ADDENDUM #1

TO CONTRACT DOCUMENTS FOR: Project # CP242862-PICKARD HALL-PHASE 1-
SELECTIVE DEMOLITION AND RAD CHARACTERIZATION

PREPARED FOR: The Curators of the University of Missouri

D102

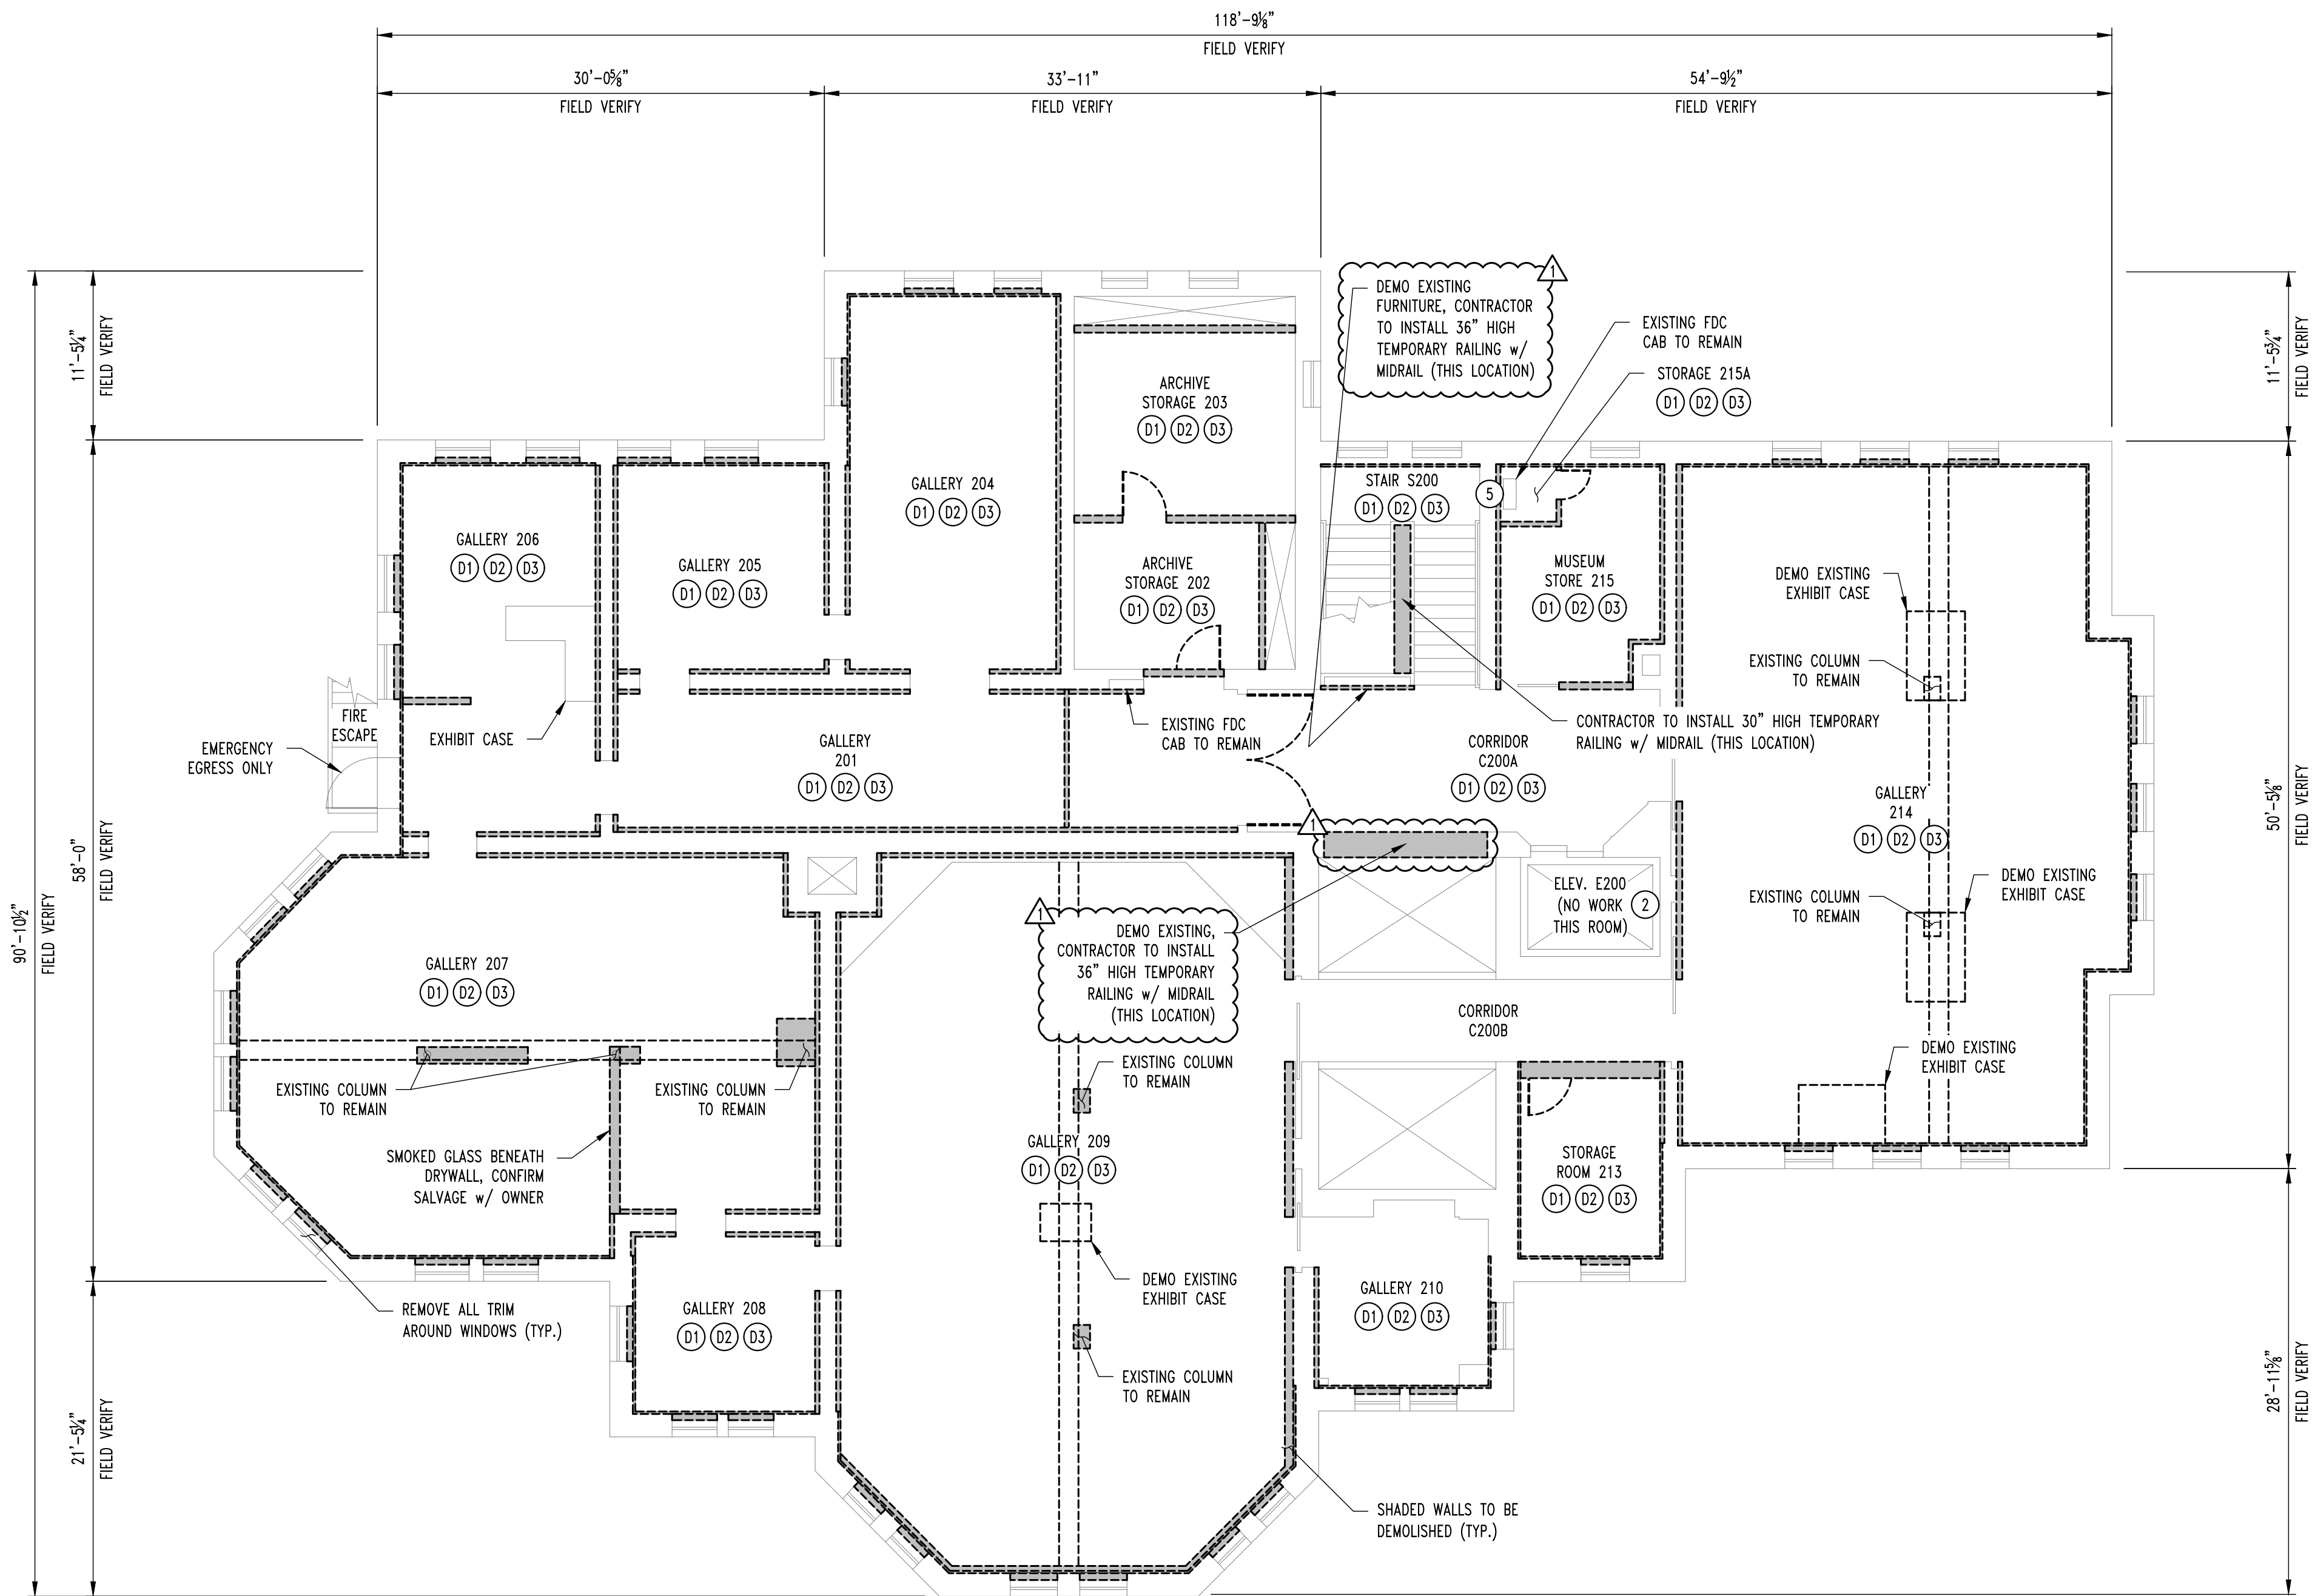
1. On Drawing sheet D102, Added notes regarding temporary guard rails.
2. On Drawing sheet ME101, updated mechanical note #2 in reference to the construction filters. Filters shall be checked/replaced biweekly; up completion of project, filters shall be changed & coils shall be cleaned.

FA102

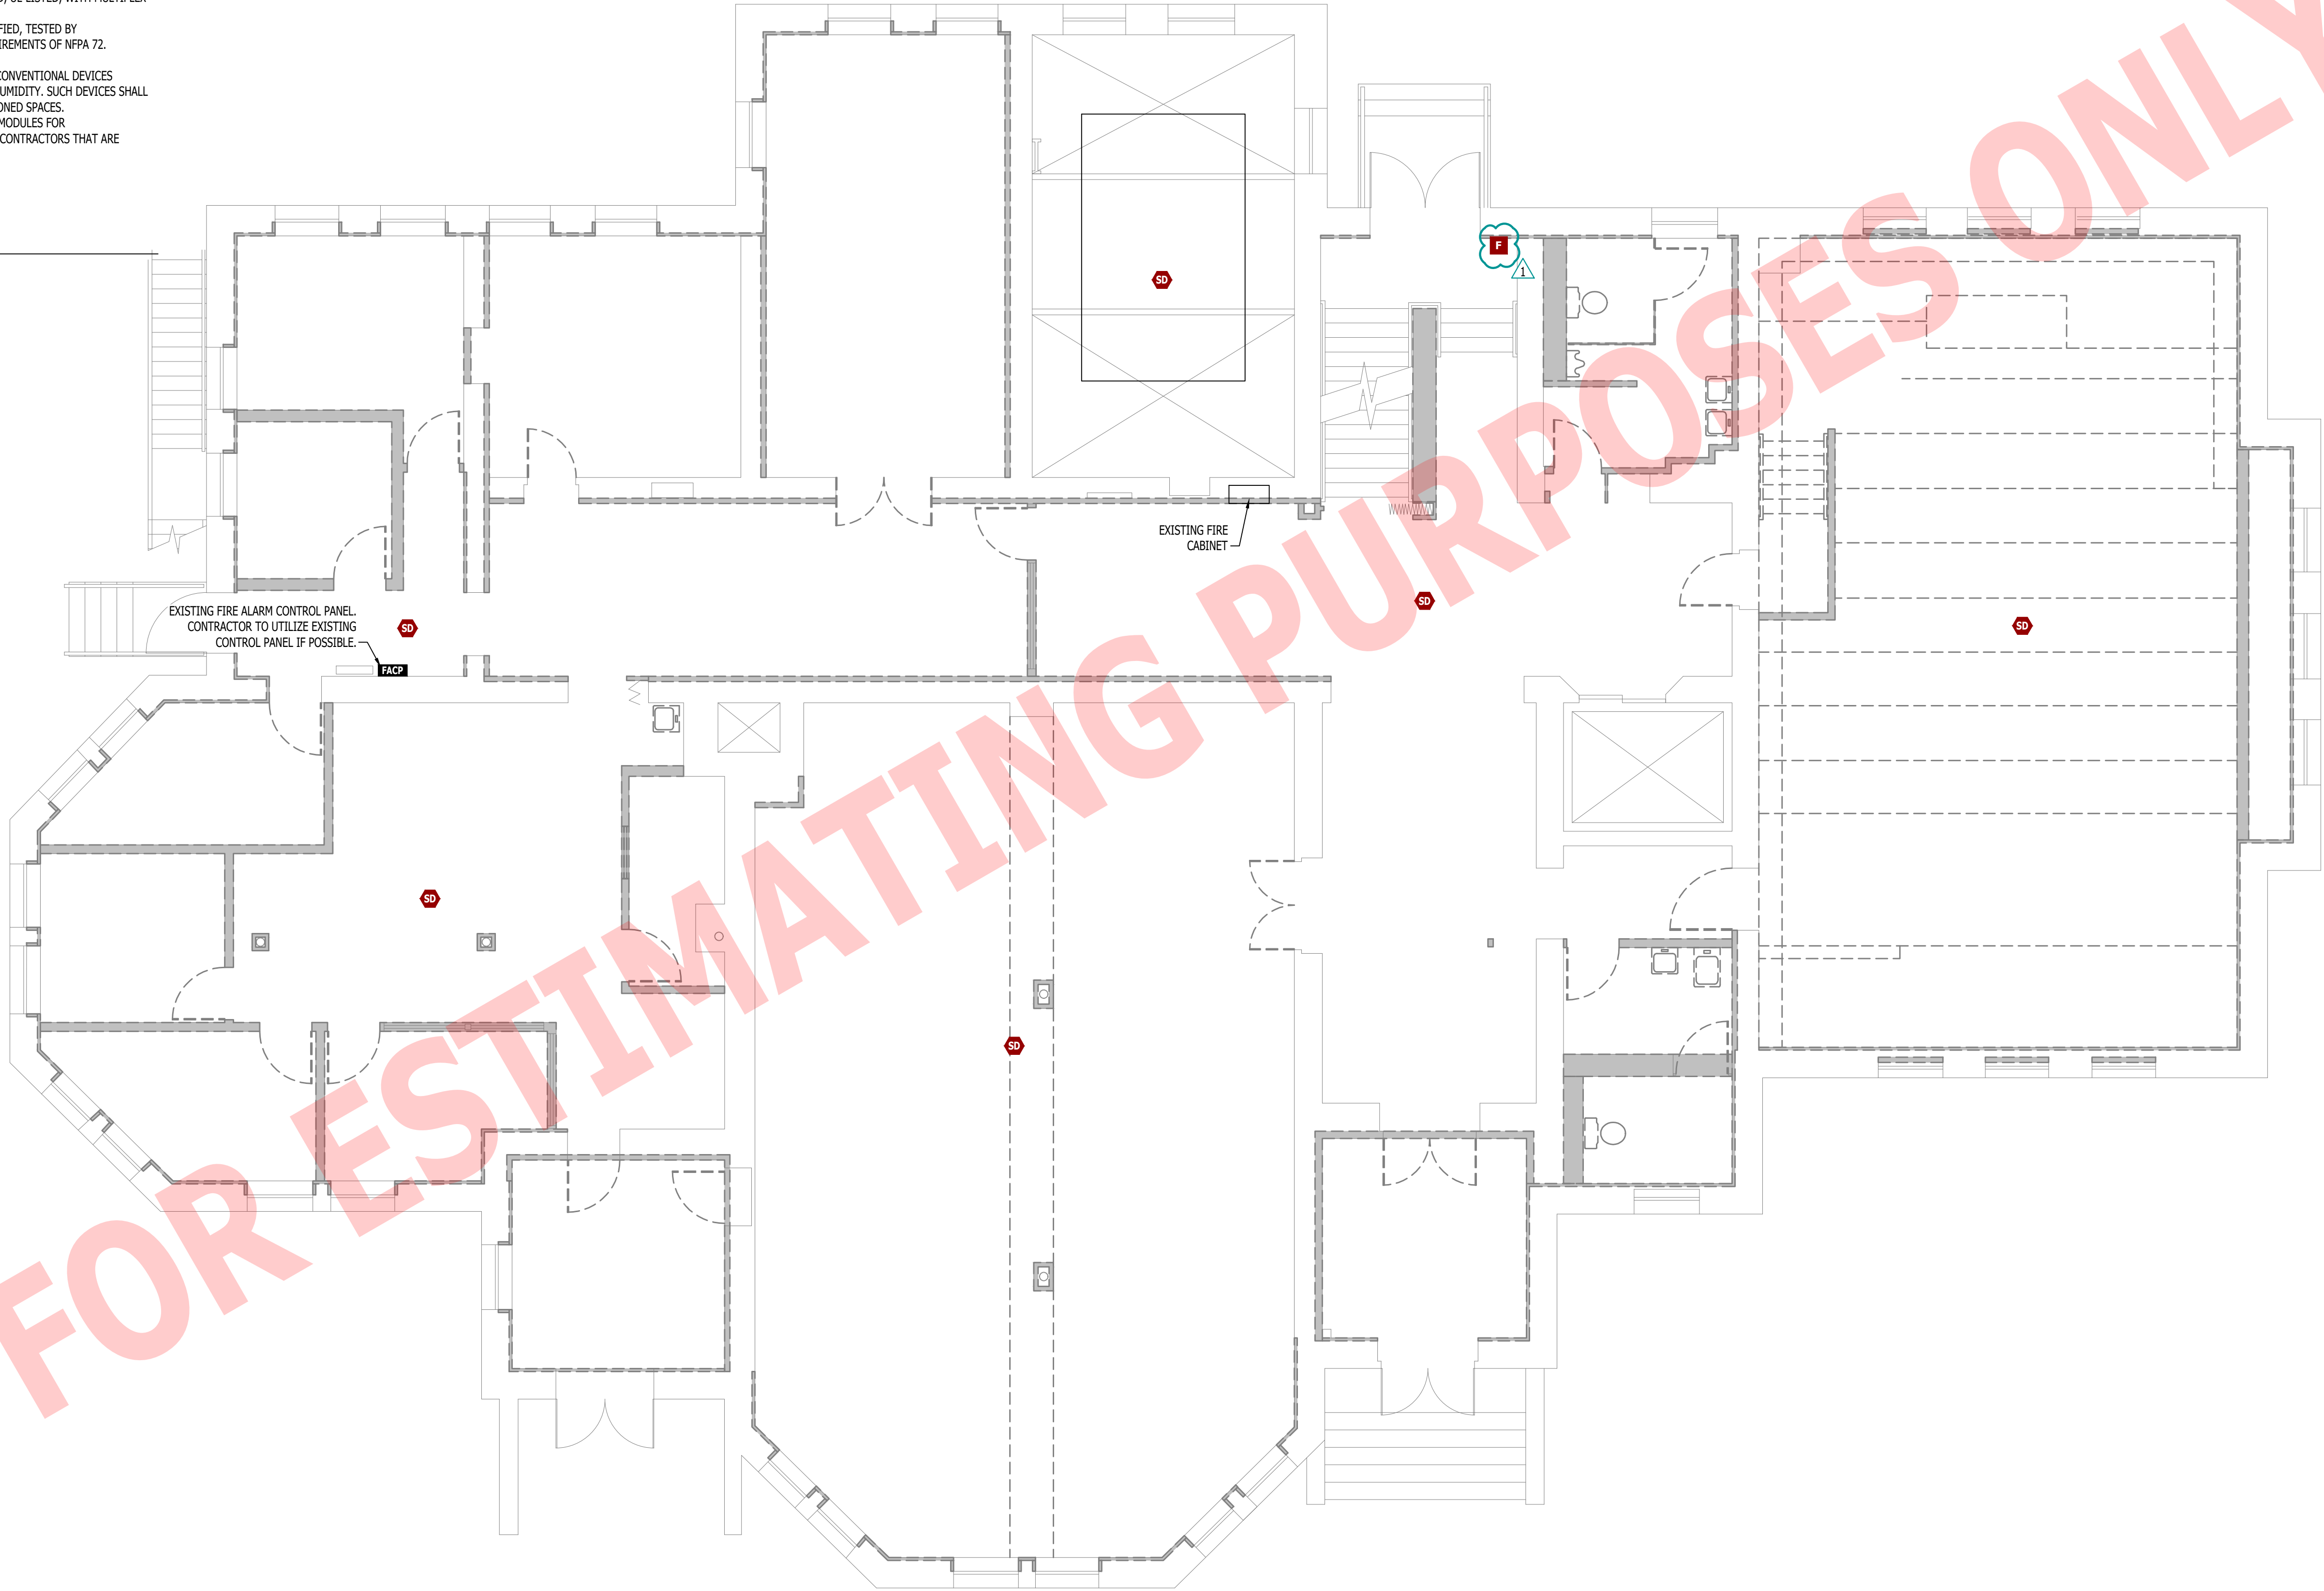
3. On Drawing sheet FA101 through FA103, fire alarm specification notes #6. No wireless systems will be allowed.
4. On Drawing sheet FA102. Added a manual pull station for the fire alarm system.
